Homewood Ref: 3998

**RE: Assessment of trees around the intersection of Deakin Avenue and O'Connor Street, Haberfield**

As per your request, an amended design (Drawing No. 82021192-01-C1010) for proposed upgrade of stormwater drainage infrastructure has been reviewed in relation to its impact to trees.

### Tree Protection Plan

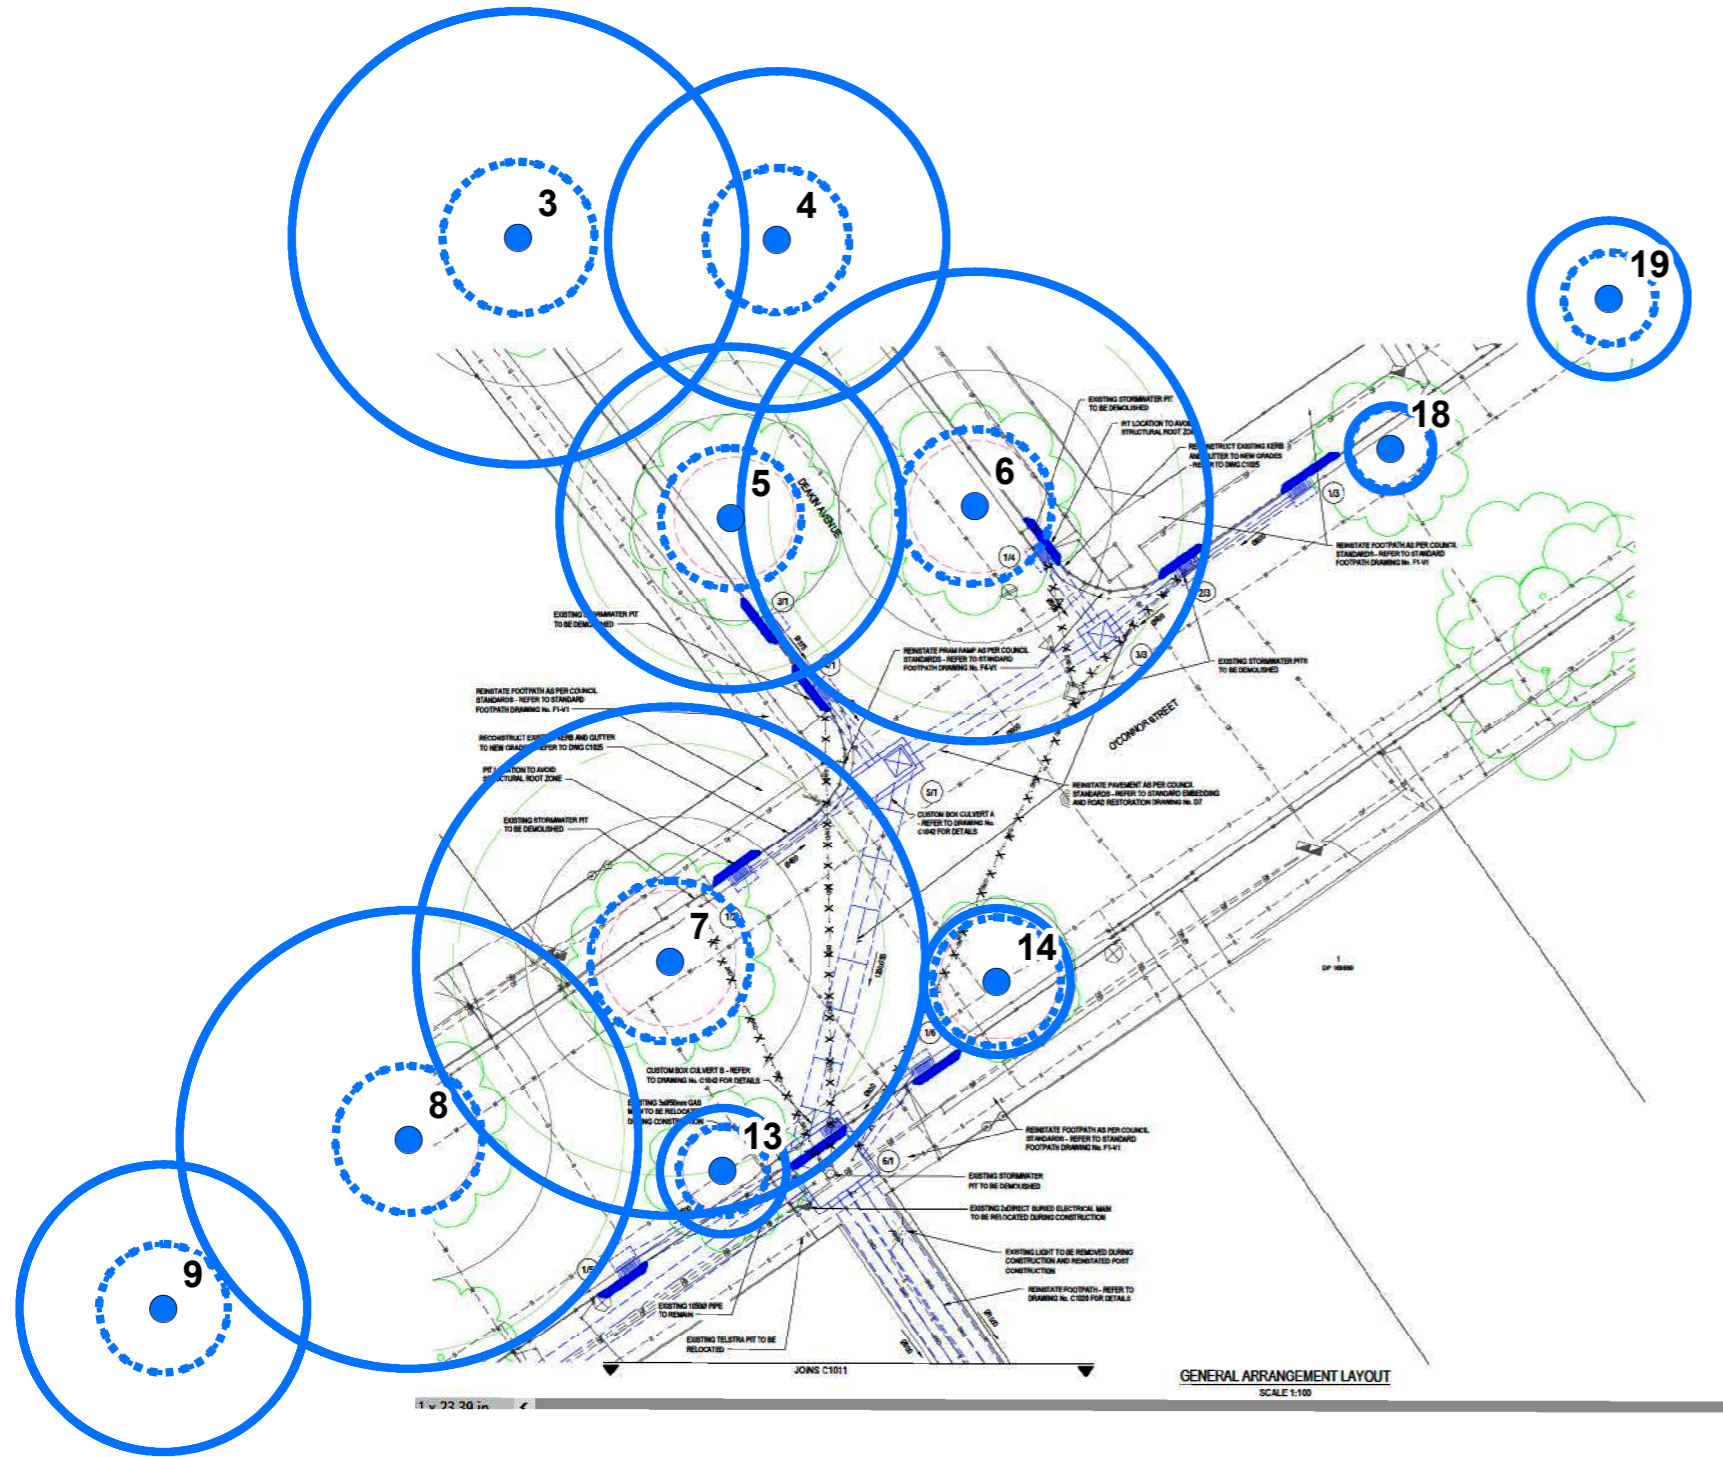
Updated plans propose trenching, with the alignment altered to reduce impact to trees. The current design is a noted improvement in regard to tree impacts when compared to the previously assessed design. Alignment of trenches and proposed works have, in general, avoided or significantly reduced encroachment of the Structural Root Zone. In terms of installation via trenching, the proposed design presents as a best-case scenario in regard to tree impacts.

One tree (Tree 18- 'Low' retention value) will require removal to facilitate the design. The remaining trees can be retained with the adoption of the tree protection measures outlined below and depicted in the Tree Protection Plan (page 4):

1. TPZ and SRZ dimensions outlined in Table 1 are shown to scale on all Site Plans.
2. Tree protection measures, as outlined in this document, are included in any site induction and all contractors are made aware of these recommended measures prior to commencing work.

3. There is no further excavation or other works undertaken beyond that which is indicated in provided plans.
4. Any works including excavation, installation or demolition/removal of infrastructure within the TPZ of retained trees is conducted under the direct supervision of the Project Arborist (minimum AQF5) and is undertaken as follows:

- 4.4 Exposed tree roots less than 40mm in diameter may be cleanly pruned by the Project Arborist at right angles using sharp, clean tools.
5. Trees 3, 5 and 7 are pruned to obtain 3m vertical clearance over the proposed works area prior to the commencement of works.

6. Trunk protection, as outlined in Figure 1, is installed around Trees 5-7, 13 & 14.
  - 6.1 Protection may consist of padding surrounding the trunk or branch, held in place with batons strapped together, or similar. Boards are to be strapped to trees, not nailed or screwed.
